Access Compliance Report Public Rights-of-Way (Curb Ramps)

Main Street: RAINIER_DR		Cross Street: PROSPECT_AVE		Location:	SE
ADA ID: RPAT211022144424	Ramp Type:Type 1 - Perpendicular Diagonal Initial Pass/Fail: Fail		Overall Compliance: No	Severity Score:	15
Codes/Mitigation Info/Possible Solution			Field Measurements/Component Compliance

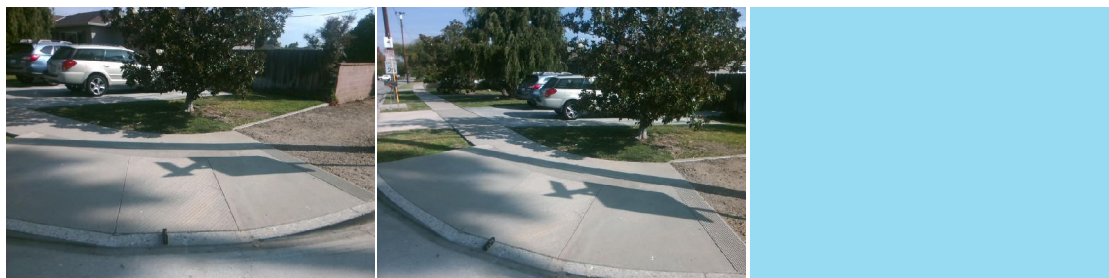
Compliance	Description	Data	Compliance	Description	Data
N/A	Ramp Length (in)	69	N/A	Flare Type LT	
Yes	Ramp Width (in)	48			N/A
No	Ramp Run Slope (%)	9.8	N/A	Flare Slope LT (%)	N/A
Yes	Ramp Cross Slope (%)	1.1	N/A	Flare Traversable LT	N/A
N/A	Landing Present	N/A	N/A	Flare Type RT	
N/A	Landing Length (in)	N/A			N/A
N/A	Landing Width (in)	N/A	N/A	Flare Slope RT (%)	N/A
N/A	Landing Run Slope (%)	N/A	N/A	Flare Traversable RT	N/A
N/A	Landing Cross Slope (%)	N/A	N/A	DWS Provided	N/A
N/A	Landing Movement Obstructed?	N/A	N/A	DWS Contrast	N/A
	Landing Movement Type	N/A	N/A	DWS Length (in)	N/A
N/A	Landing Shared	N/A	N/A	DWS Full Width	N/A
N/A	Clear Space	Yes	N/A	DWS Offset Left (in)	N/A
N/A	Clear Space To Crosswalk (in)	N/A	N/A	DWS Offset Right (in)	N/A
N/A	Marked Crosswalk 1	No	N/A	Marked Crosswalk 2	No
	Crossing 1 Direction	NE		Crossing 2 Direction	NW
	Marked Crosswalk 1 Width (in)	N/A		Marked Crosswalk 2 Width (in)	N/A

N/A	Ramp Inside Crosswalk 1	N/A	Yes	Ramp Inside Crosswalk 2	N/A
	Crossing 1 Slope (%)	3.6		Crossing 2 Slope (%)	6.8
	Crossing 1 Cross Slope (%)	2		Crossing 2 Cross Slope (%)	0.3
N/A	Gutter Ponding	N/A	No	Curb Slope	6.7
Yes	Gutter Lip Height (in)	0		Road Run Slope (%)	5.2
N/A	Gutter Run Slope (%)	N/A		Road Cross Slope (%)	0.6
N/A	Gutter Cross Slope (%)	N/A			
Yes	Overall Surface Condition: Acceptable		Yes	Perp Joint Present	Yes
	Cross Gutter Present?	Yes		Spandrel Present?	Yes
	Replace Cross Gutter?	No		Replace Spandrel?	No

Remove & Replace Curb Ramp With Two New Directional Ramps or Equivalent.

R304.2.2, STD 1115
